# Feasibility of using White Noise Interference in the EIT Test

Vivek Telang  
April 19, 2006

# Recap: Comment 31

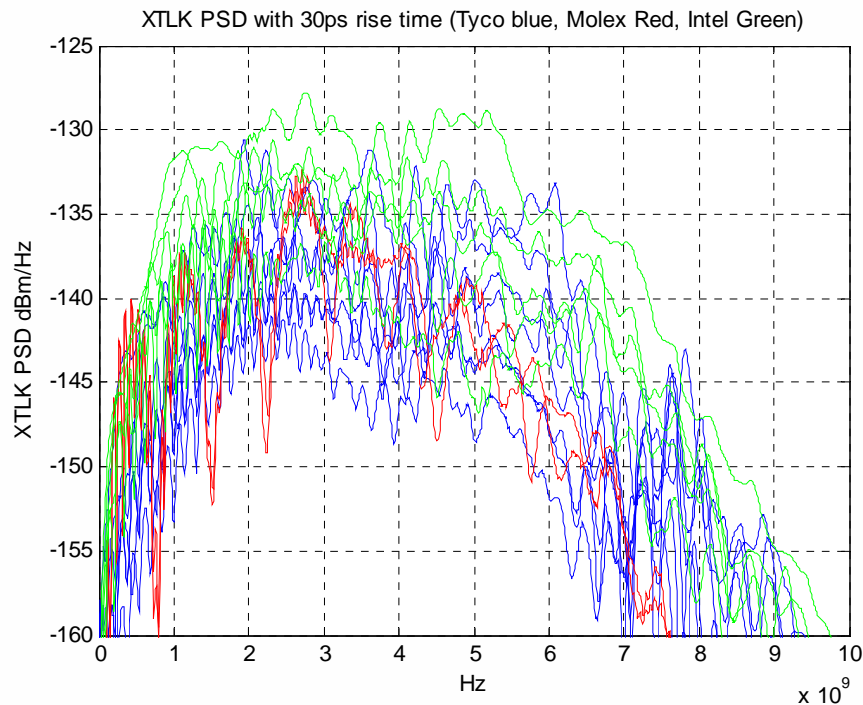
A sinusoid interferer does not accurately capture the intent of this test, which is to evaluate the tolerance of a receiver to a crosstalk interferer, for the following reasons:

1. As pointed out by Fulvio in a recent channel ad-hoc conference call, the pdf (histogram) of a sinusoid is significantly different from that of a crosstalk interferer
2. A receiver could be ""built-to-the-test"" with a 2-tap predictive noise canceller that could effectively cancel any sinusoid in the signal passband. Clearly, this would have no correlation to the receiver's ability to tolerate real crosstalk (False Positive)
3. A well-designed receiver capable of tolerating crosstalk might fail this test for completely different reasons, e.g. an adaptation loop might mistrain (False Negative)

For all the above reasons, this test should be designed to use an interference signal that is richer than a single sinusoid

Define the EIT to use either white noise, or shaped (colored) noise to mimic a real crosstalk power sum. The shaping filter could be built fairly easily with either R,C components, or even using cabling or PCB traces. This approach has been used for crosstalk testing of 1000BASE-T PHYs, and is also currently being specified in the 10GBASE-T draft.
